GeoSolv, LLC

Subject: Risk-Based Corrective Action of Hydrocarbons related to the Former Underground Storage Tanks at the FORMER BILL CHUN SERVICE STATION @ 2301 SANTA CLARA AVENUE, ALAMEDA, CA 94501

Figure 1 Site Conceptual Model for the former Bill Chun's Service Station Site, Alameda, CA

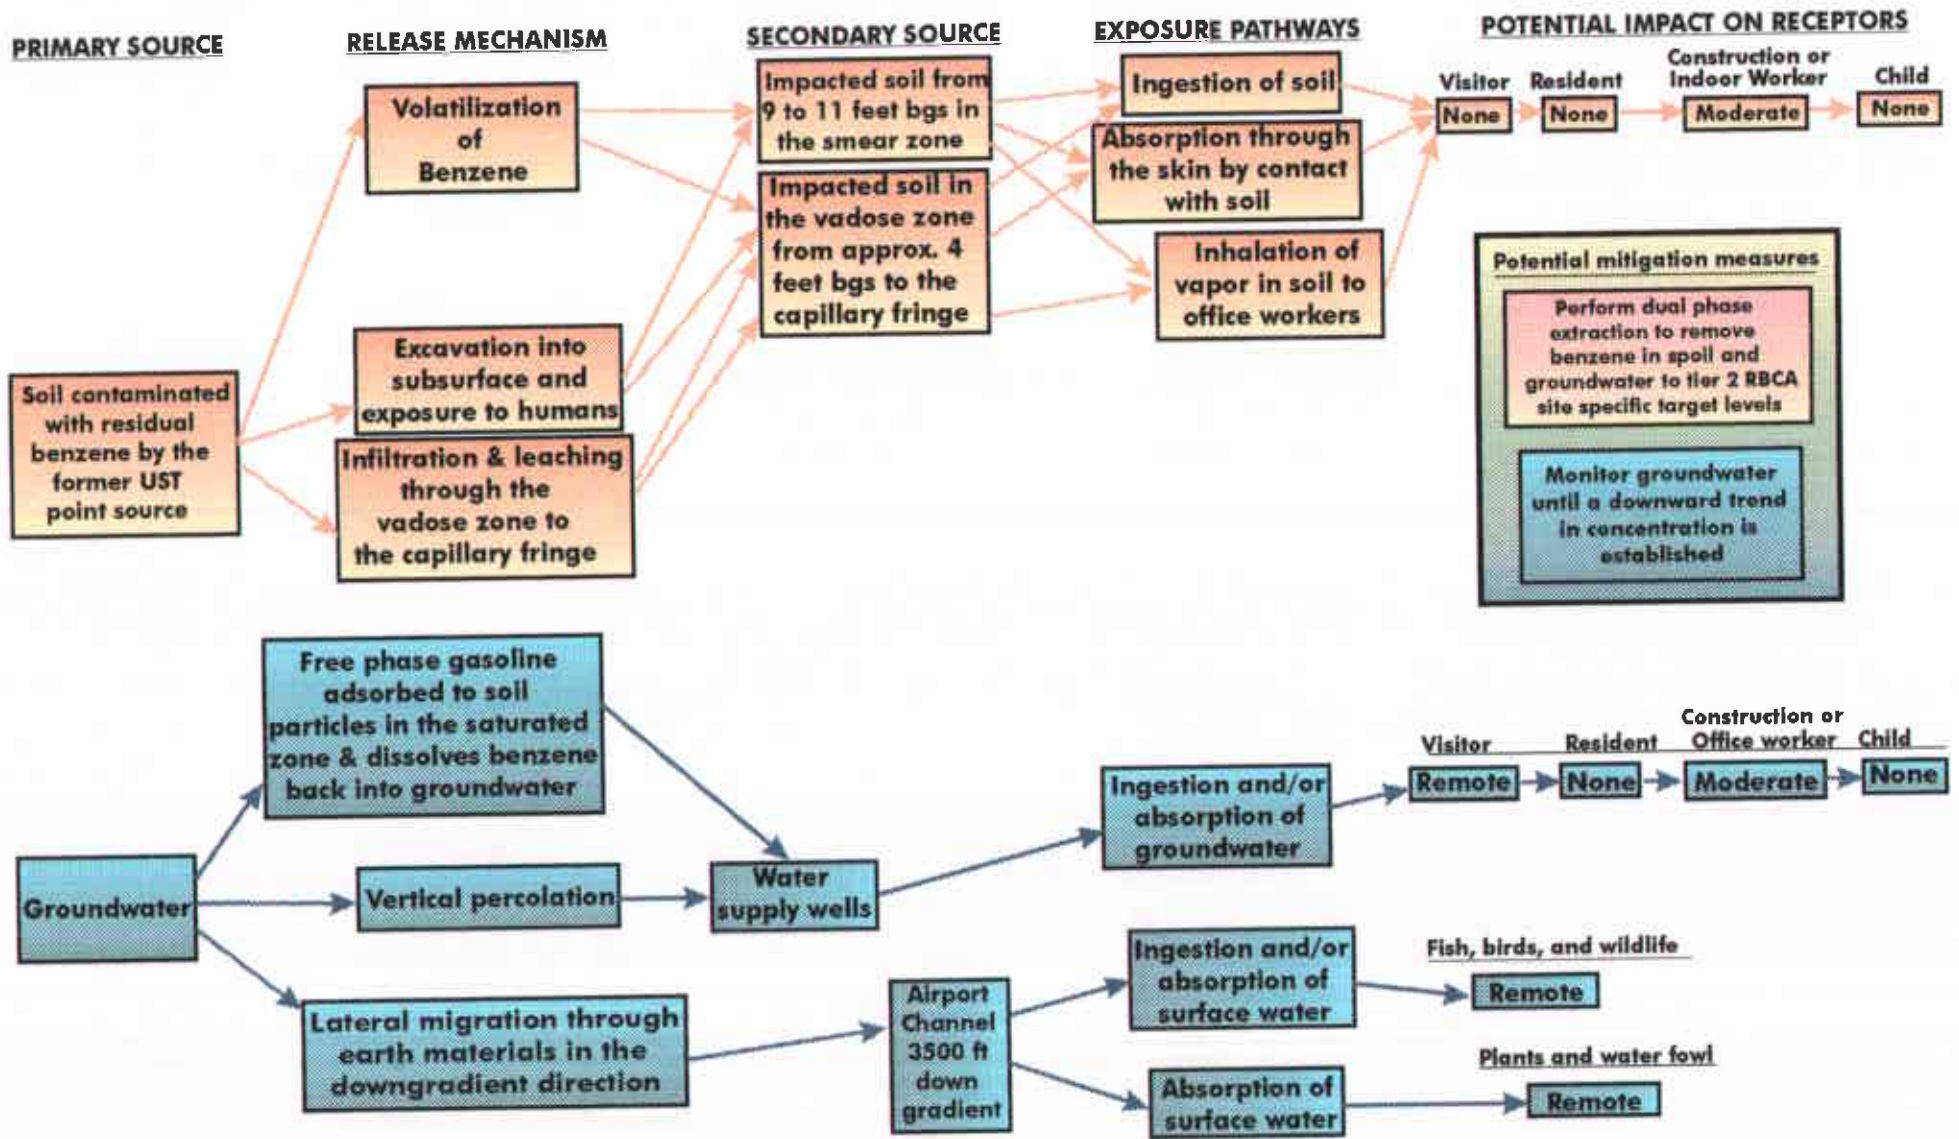
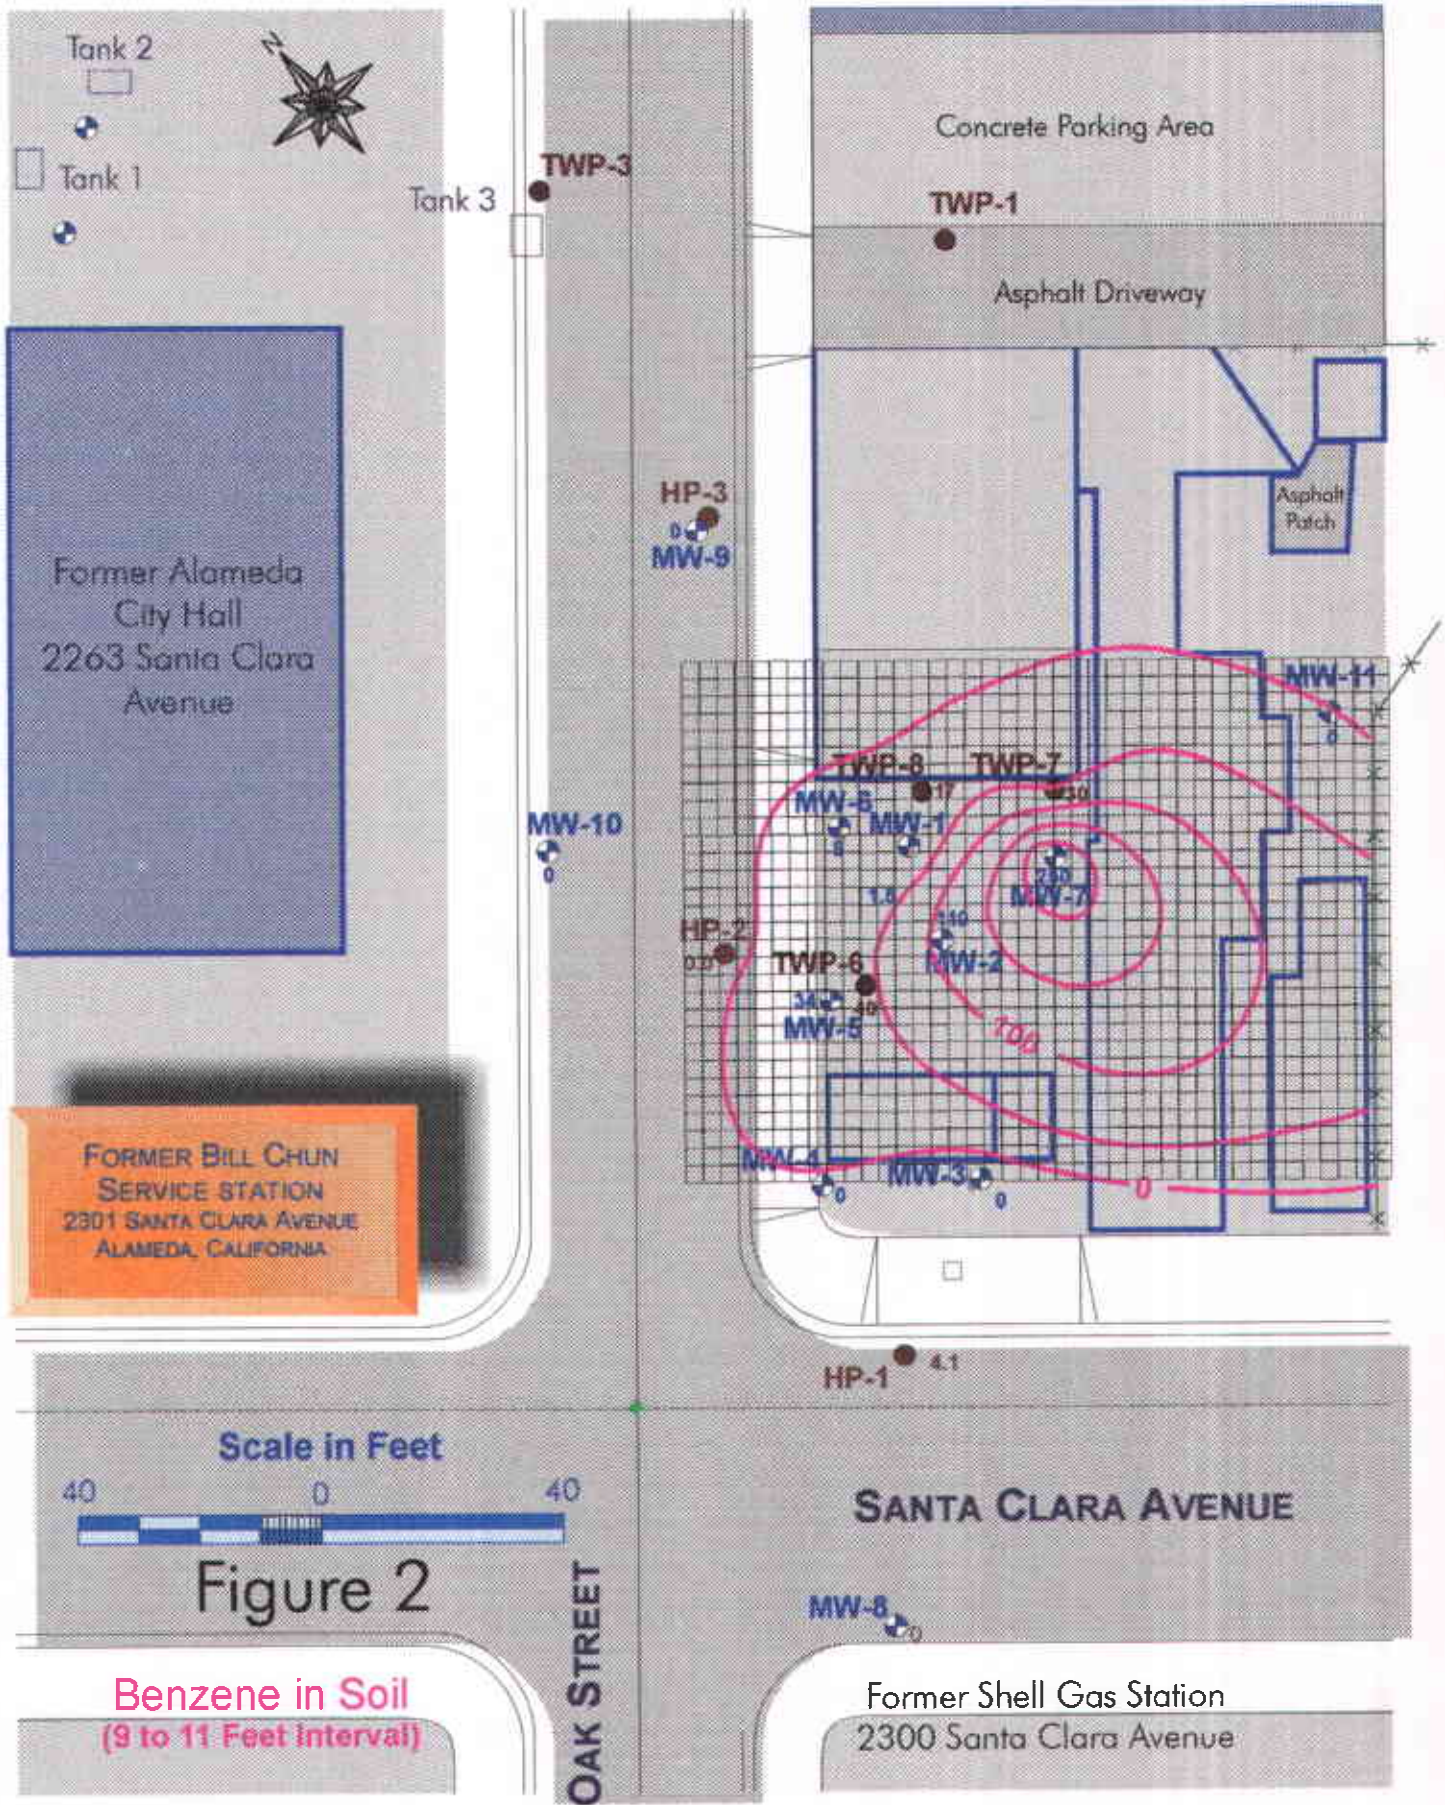
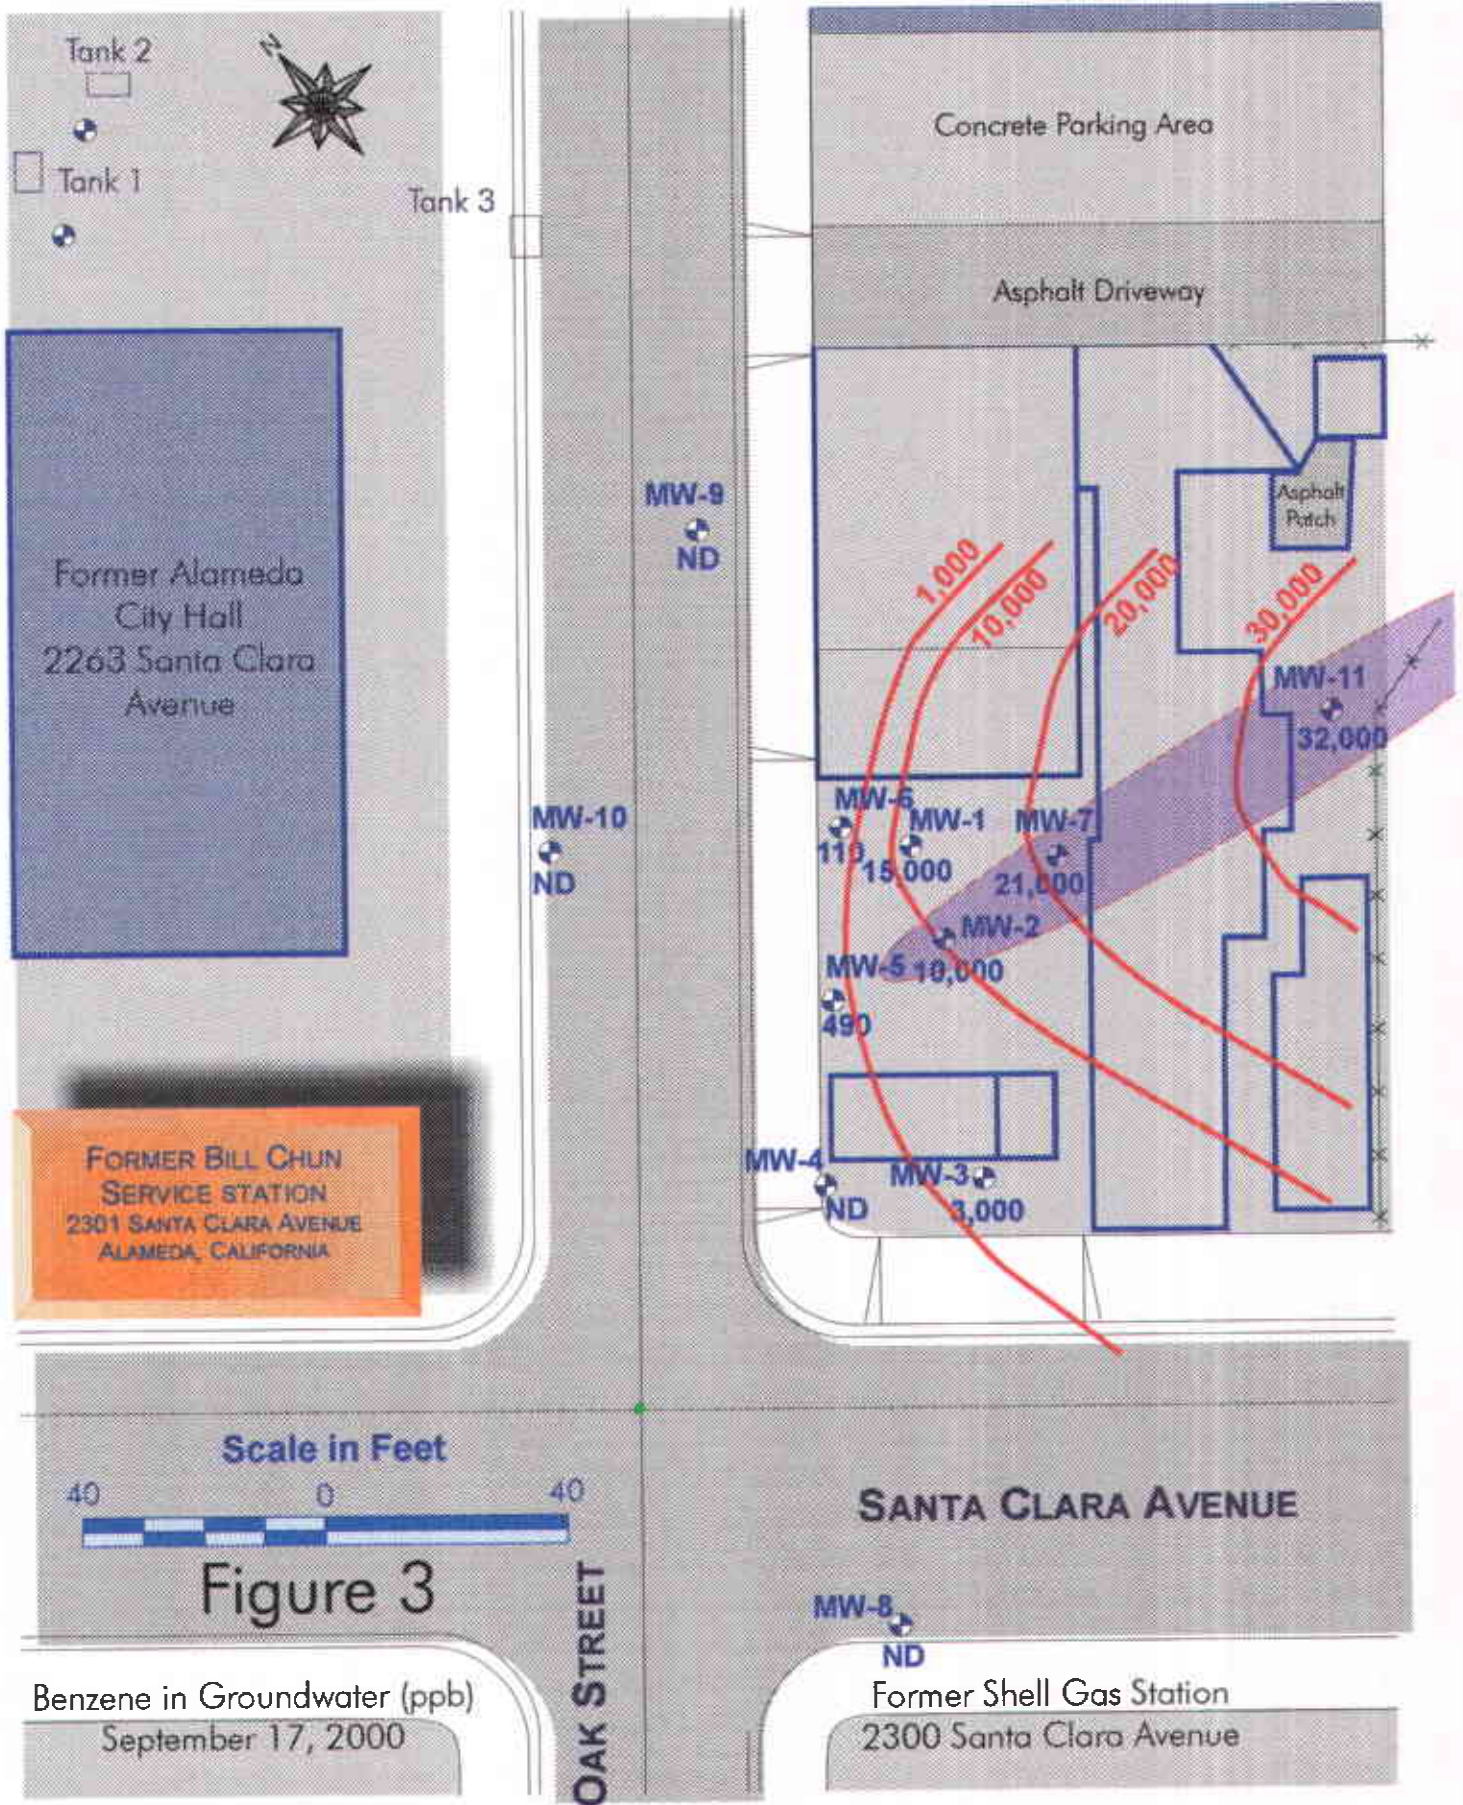
Environmental risks were evaluated in general accordance with the "Site Conceptual Model" (Figure 1). Benzene has been evaluated as the main indicator chemical of concern.
